Hydraulic Modelling Addendum

Job Name Peartree Hill Solar Farm

Job number 20-206

1.1.1 This Technical Note discusses additional work carried out to support proposed Solar PV development at Peartree Hill following the Environment Agency (EA) review of the development proposals and hydraulic modelling. It forms an addendum to the Peartree Hill Solar Farm Hydraulic Modelling Report 20-206-60-050.

Figure 3-1 Missing Structures

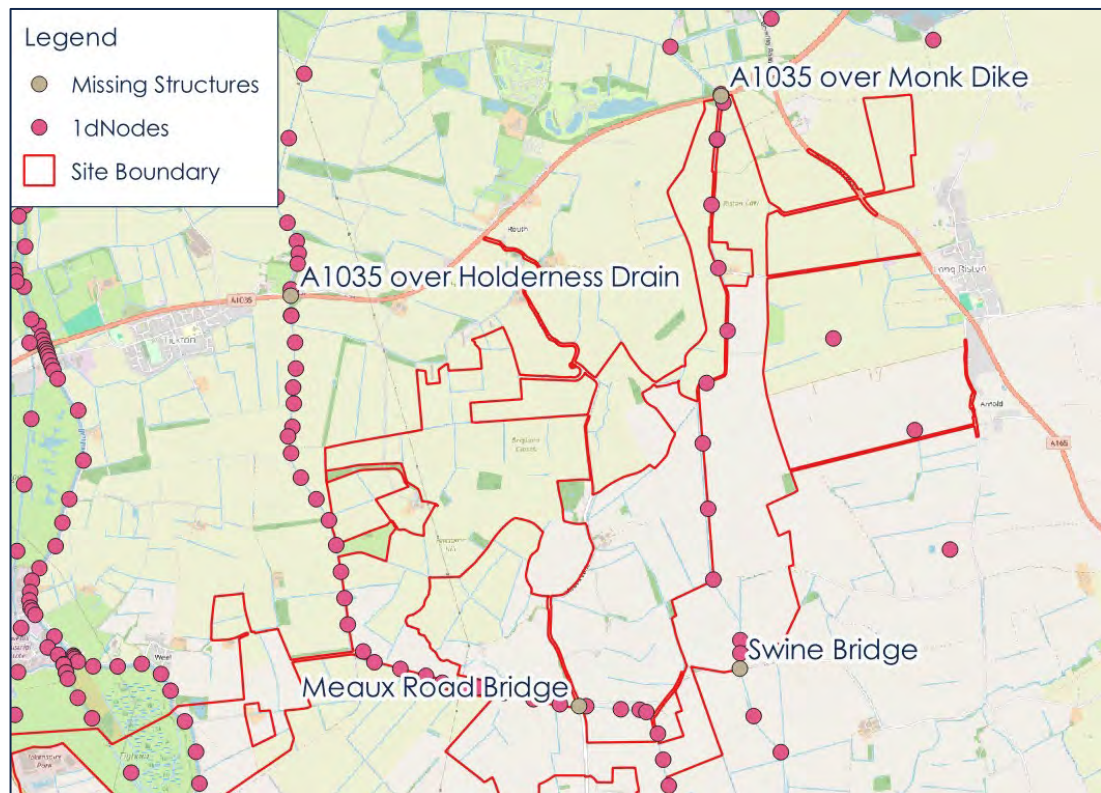
- 3.1.1 The EA model review notes a number of missing structure in vicinity of the site as listed below and shown in Figure 3-1:
- A1035 bridge over Monk Dike (FM cross section Cat00000)
 - A1035 bridge over Holderness Drain (FM cross section HN43),
 - Swine Road Bridge over Monk Dike (closest FM cross section MK4055), and
 - Meaux Road Bridge over Holderness Drain (FM cross section HN21).

- 3.1.2 Three of these structures have been added to the model using available data and where information was sparse a conservative approach to the structure definition was taken. The structure at HN21 as it appears to be a clear span structure with the deck approximately 3m above the maximum water level. Structure details definitions are appended to this document.

- 3.1.3 The model was reran with the design event flood. The maximum flood level was compared with the existing baseline design event outputs and the results are shown in Drawing 20-206-60-255-00 & 20-206-60-256-00.

- 3.1.4 Flood levels are generally within +/-20mm within the site boundary, the exception being a small part of parcel B1 where levels are reduced by 60mm and land west of parcel F12 where levels are reduced by 180mm. The only significant increase within the site are the parcels to the east of the Monk Dike (B2-4, B8 & C1-C3) where levels increase by 20mm. The change in outline is insignificant.

Figure 4-1 Gauge Locations.

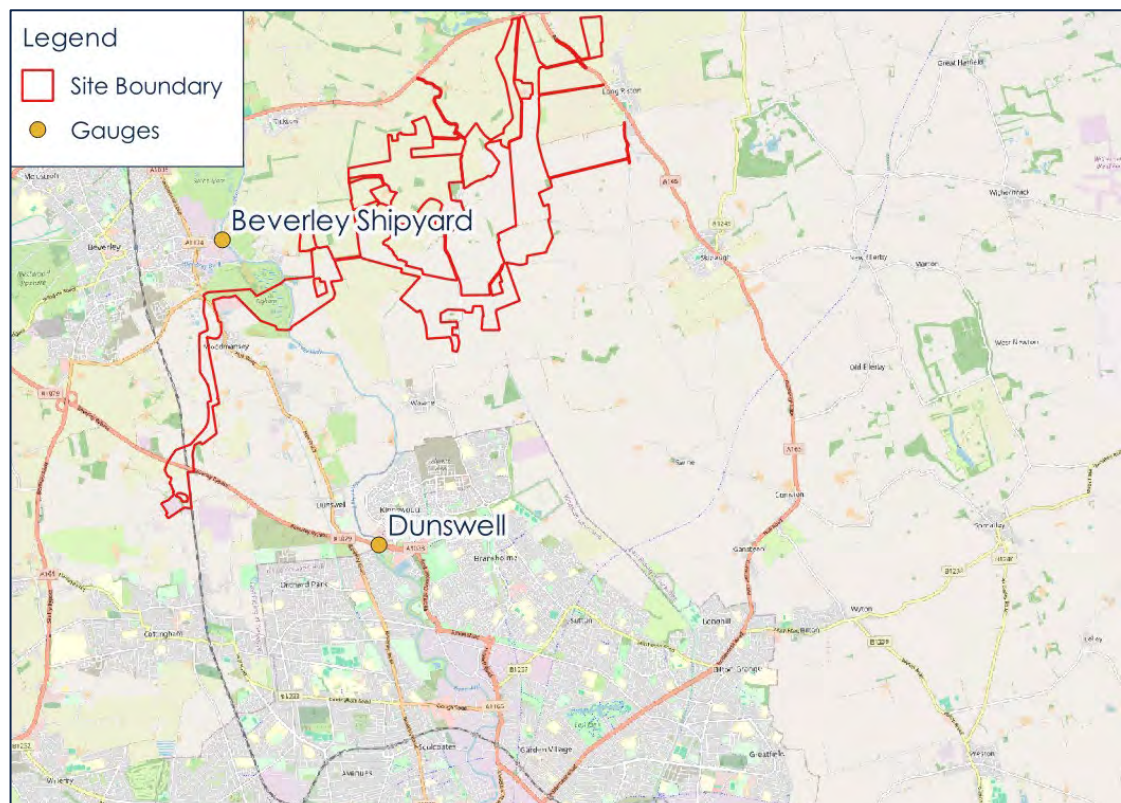
The EA model review spreadsheet includes peak water levels for most years for two gauges: Dunswell gauge starting from 2001 and the Beverley Shipyard gauge starting from 1994. The location of the gauges is shown in Figure 4-1.

5.1.1 Both of these gauges are located on the River Hull which is heavily tidally influenced and drains a large catchment so the causes of high levels are difficult to apportion. This is complicated by the fact the tidal ingress and fluvial egress are prevented when the Hull Tidal Surge barrier is closed.

20-206-60-253-00 Monk Dike Defence Removal West – 1 in 100yr +17% Depths

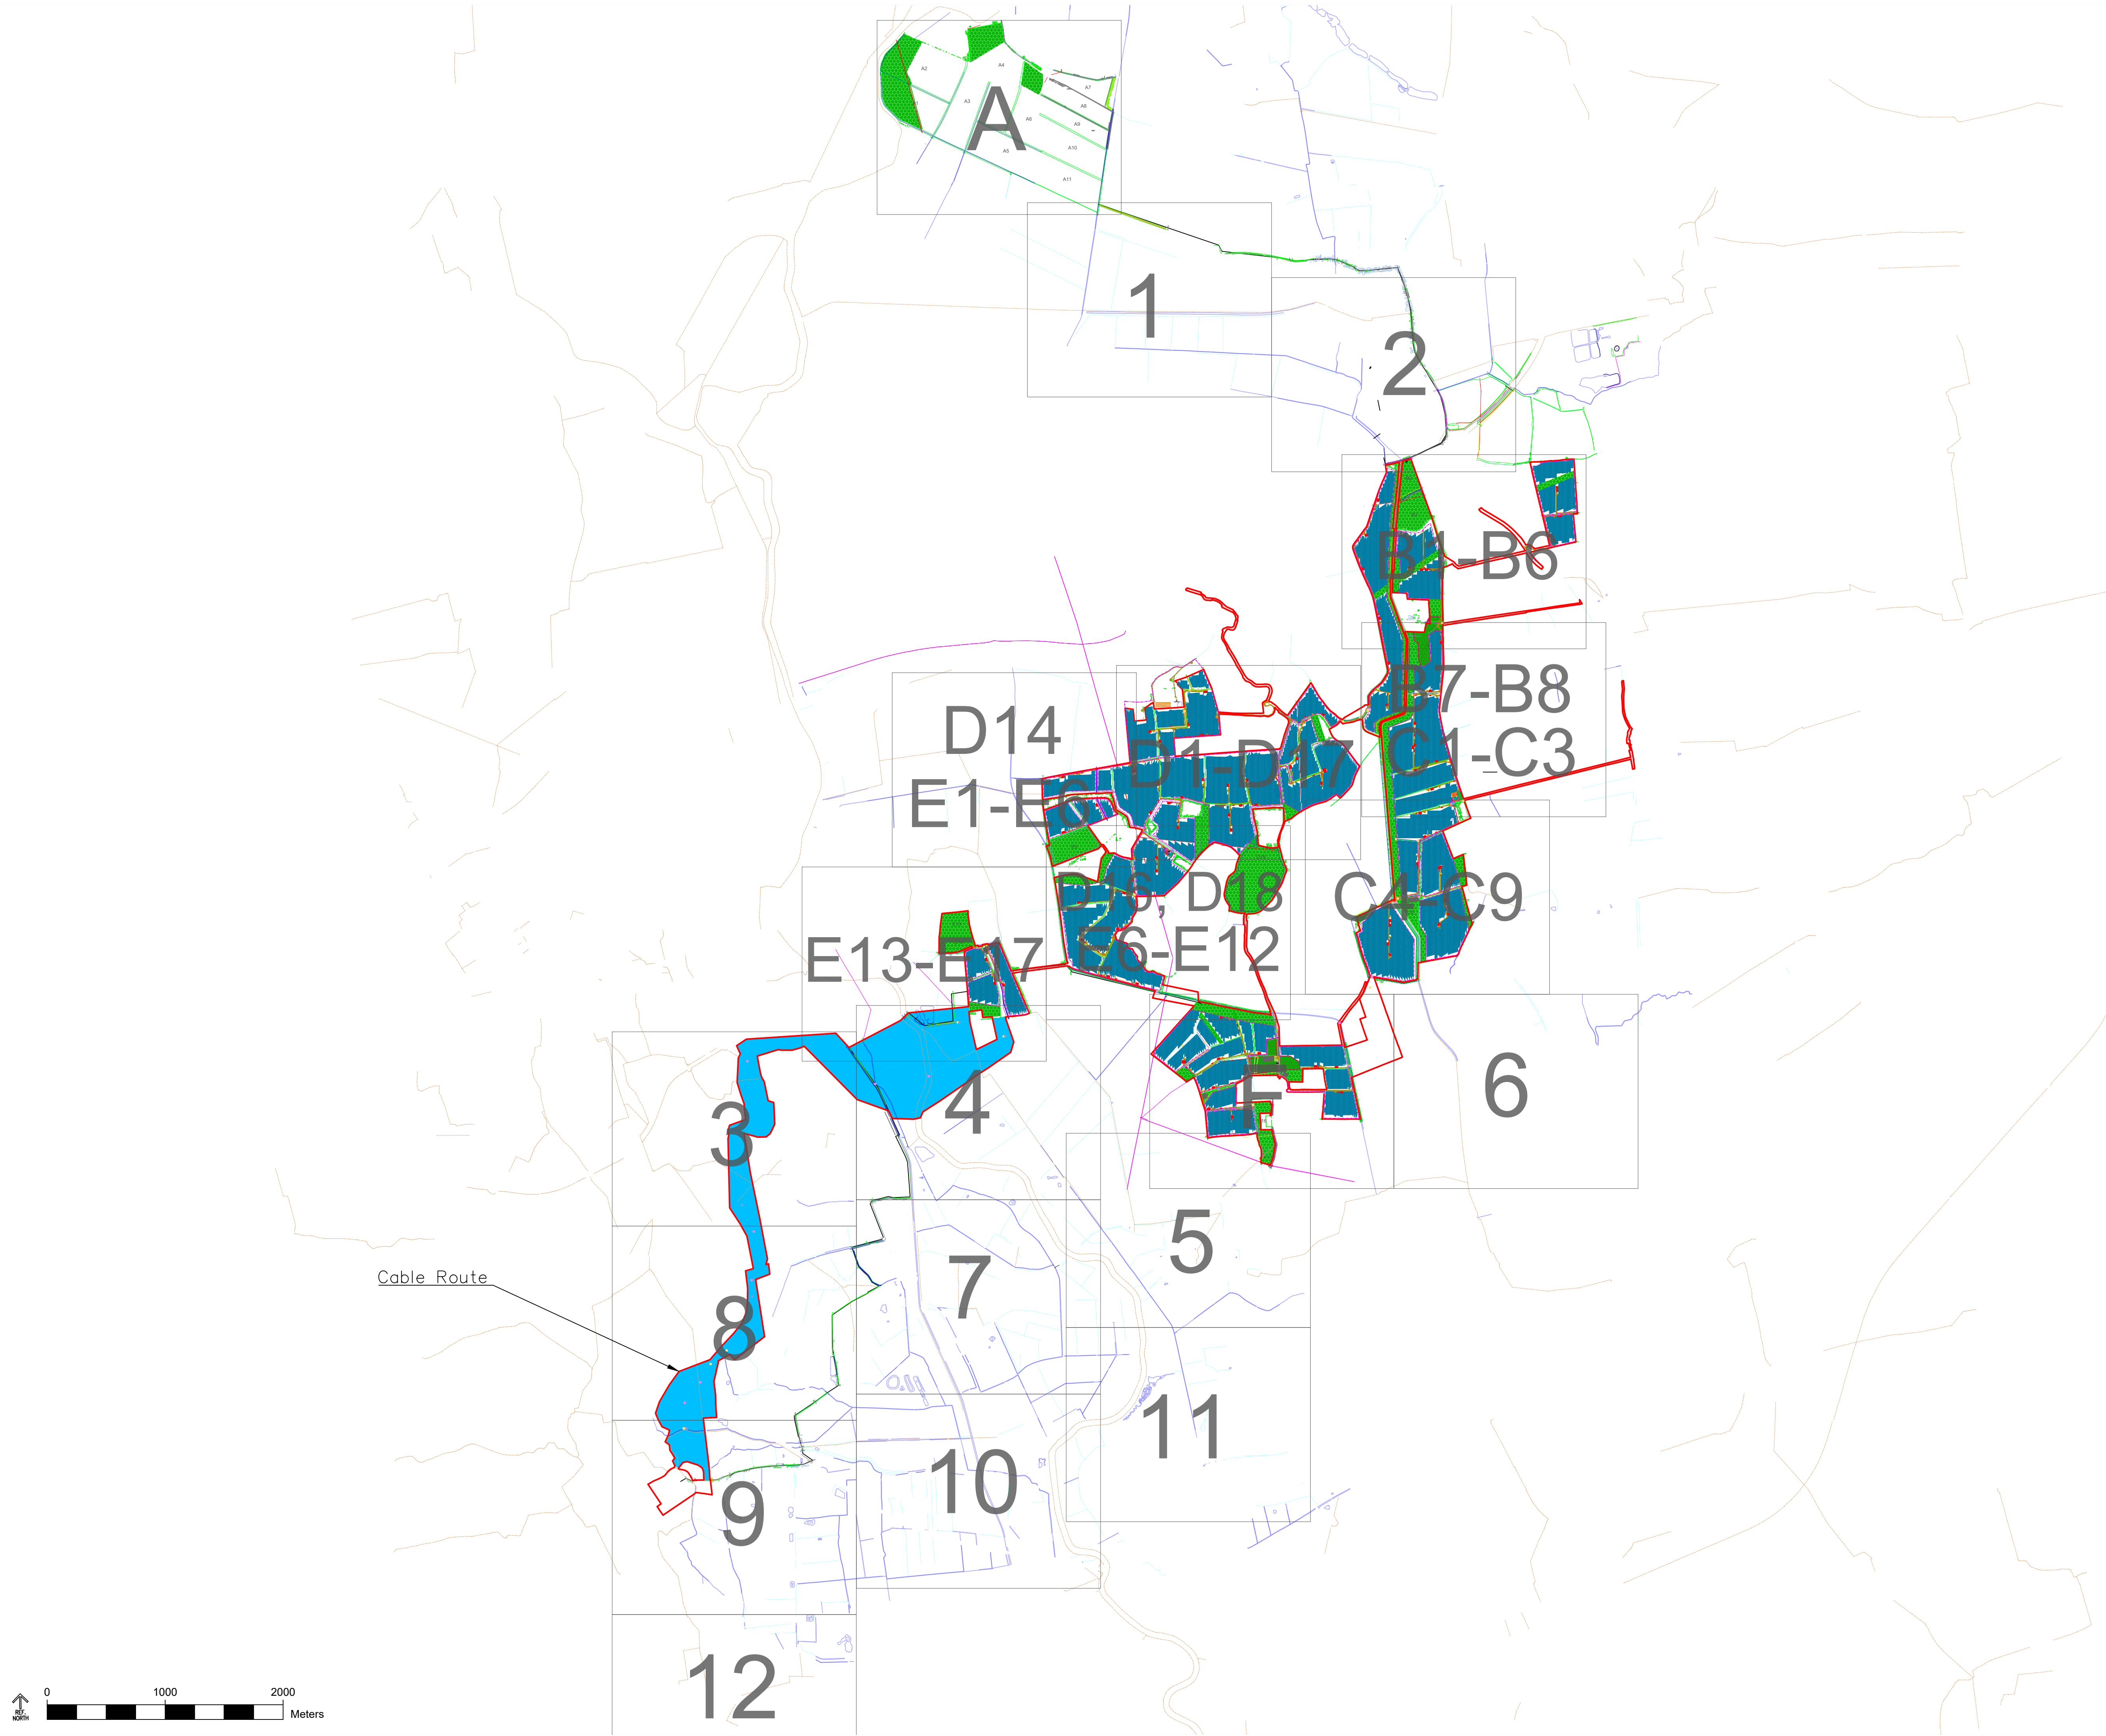
- 2.2.12 The Monk Dike embankments adjacent to proposed solar development were last inspected in 2024. The left (eastern bank) is recorded as meeting it's target condition of 3 – Fair. The northern section of the right (western) bank is in below it's target condition being recorded as 4 – Poor.

- 2.2.13 A simulation was carried out to determine the impact of complete failure of this defence by adjusting model bank lines to match existing ground levels at the toe of the defence. In essence this represents a situation where the defence is completely removed for its entire reach of approximately 4km.

- 2.2.15 The results of this simulation for the future 1 in 100 year flood is presented in Drawing 20-206-60-253-00 appended to this note. The drawing shows that the extent of flooding on the site only marginally exceeds the maximum breach extent. A review of modelled depths reveals that the flooding is not increased significantly when compared to the combined worst-case from the breach scenarios for the vast majority of the site. The exception being in Parcels B1 & B7 where flood levels are typically 0.1m higher.

- 2.2.18 The results of this simulation for the future 1 in 100 year flood is presented in Drawing 20-206-60-253-00 appended to this note. The extent of flooding adjacent to the section of defence removed is almost identical to the worst-case breach scenario and flood levels are just 5mm higher.

1 A1035 BRIDGE OVER MONK DIKE

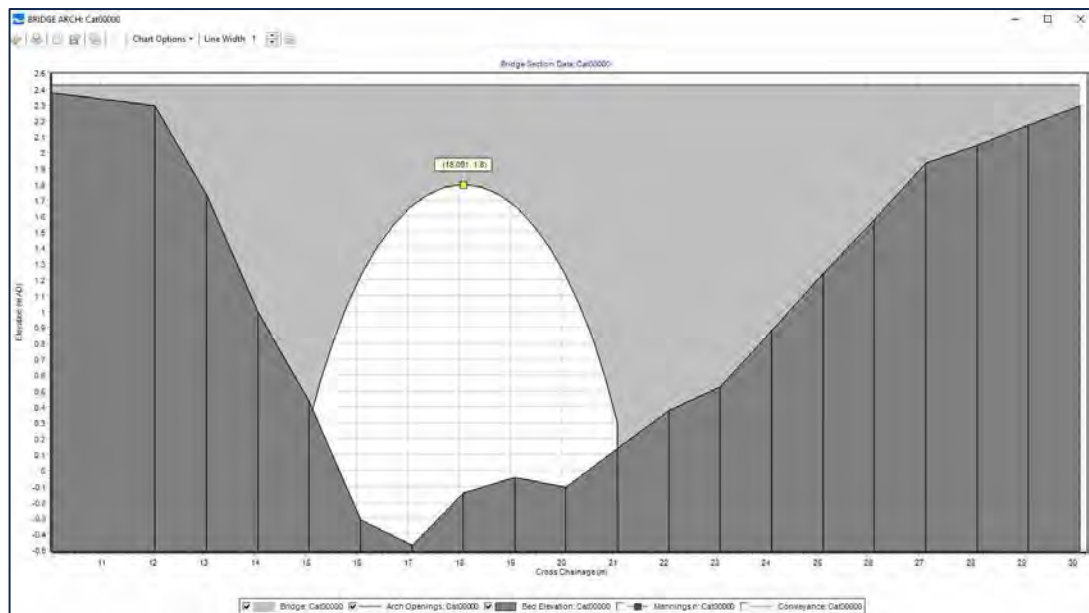
1.1.1 The arch bridge where the A1035 crosses the Monk Dike is located between node Cat00000 and Mk8550. The deck level is approximately 3.1mAOD.

1.1.2 The bridge dimensions were estimated with reference to the photos above and assumed brick dimensions of 225mm long, 113mm wide and 75mm high with and additional 10mm allowance for mortar. The parapet capping beam was assumed to be 225mm.

1.1.4 The change to the model results in a reduction in peak flood level in the Monk Dike of 8mm. There is a minor reduction in flooding to the west of Monk Dike and minor increase in flood levels to east of Monk Dike (refer to Drawing 20-206-60-255).

2 SWINE ROAD BRIDGE OVER MONK DIKE

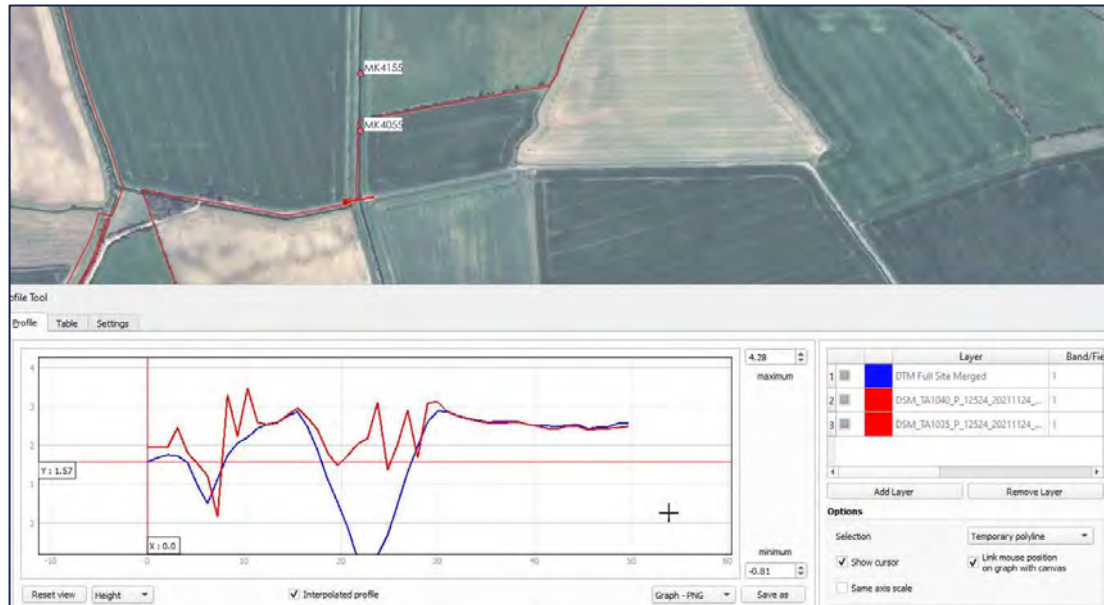
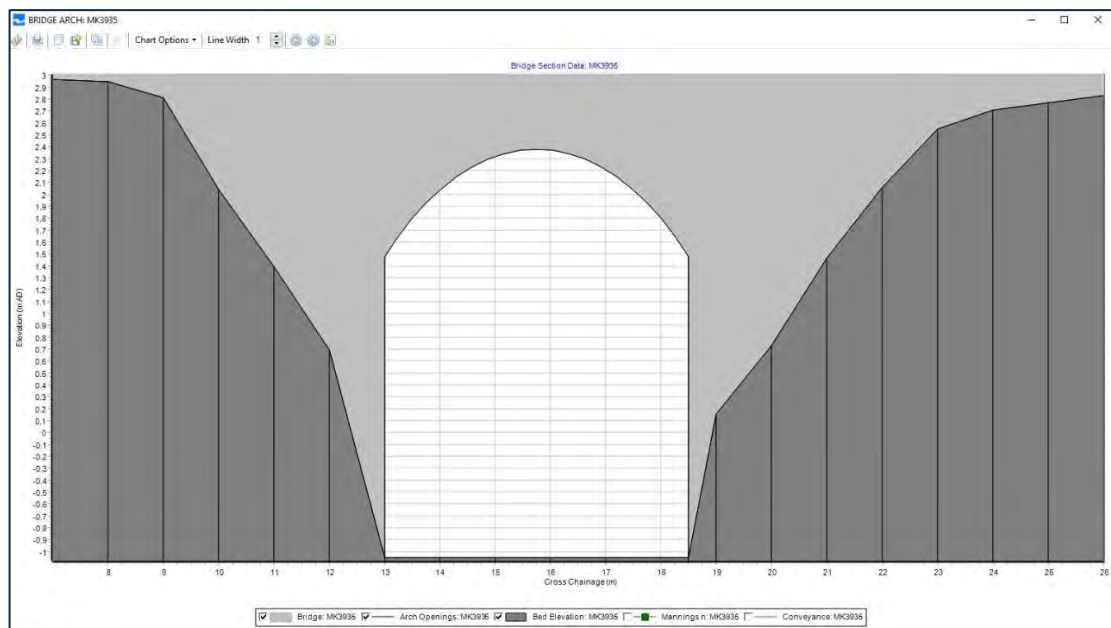
2.1.1 Swine Bridge is located between model nodes MK4055 and MK4355 just beyond the southern edge of parcel C7. The deck level is recorded by LiDAR as being approximately 3mAOD as shown below.

2.1.2 The structure dimensions were estimated from the photograph shown below.

2.1.3 The bridge dimensions were estimated with reference to the photos above and assumed brick dimensions of 225mm long, 113mm wide and 75mm high with and additional 10mm allowance for mortar. The parapet capping beam was assumed to be 225mm.

The peak flood level upstream of the bridge is within 1mm of the baseline model and consequently the definition of this bridge is not considered to be significant.

3 A1035 TICKTON BRIDGE OVER HOLDERNESS DRAIN

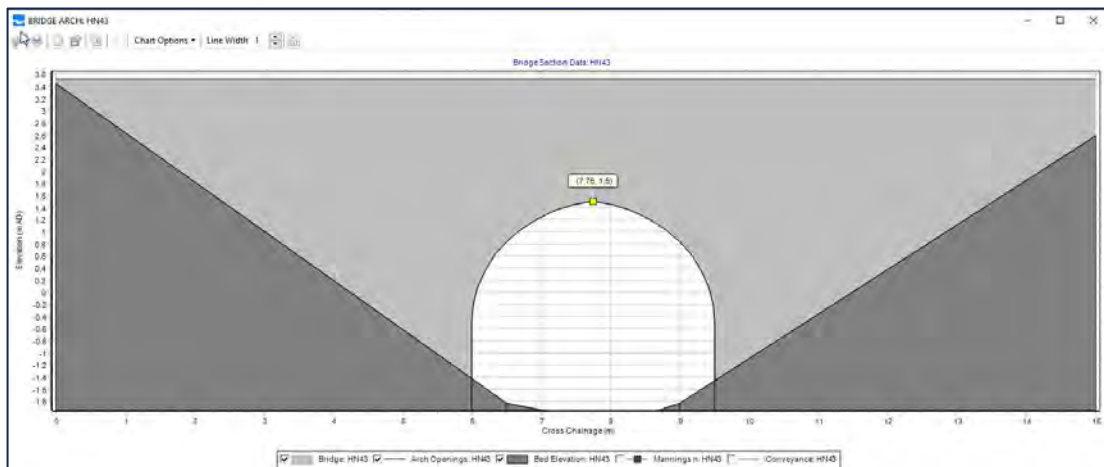
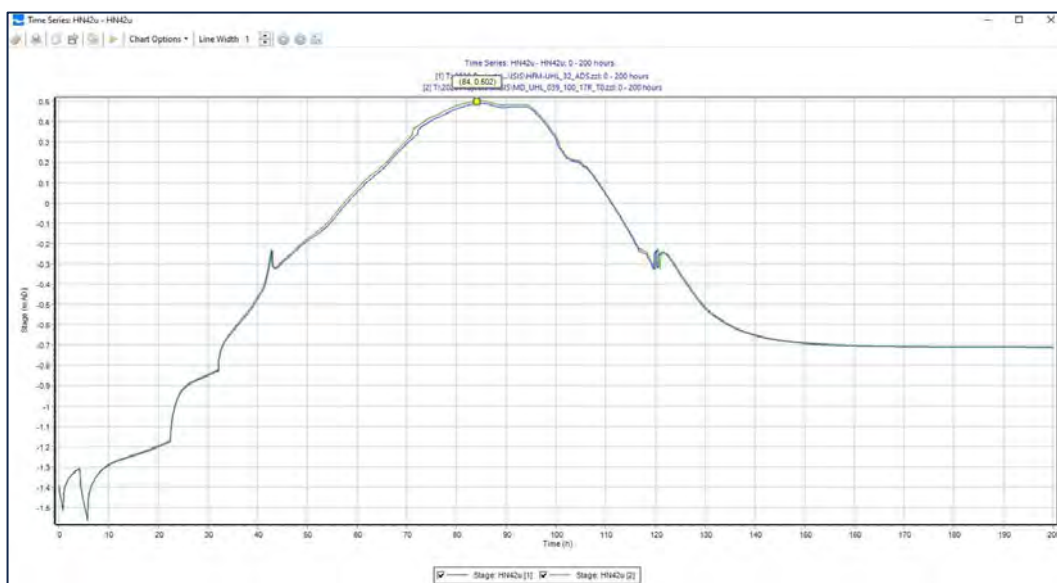
3.1.1 Tickton Bridge is located between model nodes HN43 and HN42. It is upstream of the application site. The deck level as recorded by LiDAR data is approximately 3.25m as shown below.

3.1.2 The only available information for the bridge is a photograph provided by the EA shown below.

3.1.3 It was estimated that the bridge opening is 3.5m wide with a 2m high arch and a total structure height of 3m as shown below.

- 3.1.4 The addition of the bridge results in an 11mm increase in water level just downstream of the structure as shown below and a negligible change in flood outline (refer to Drawing 20-206-60-255).
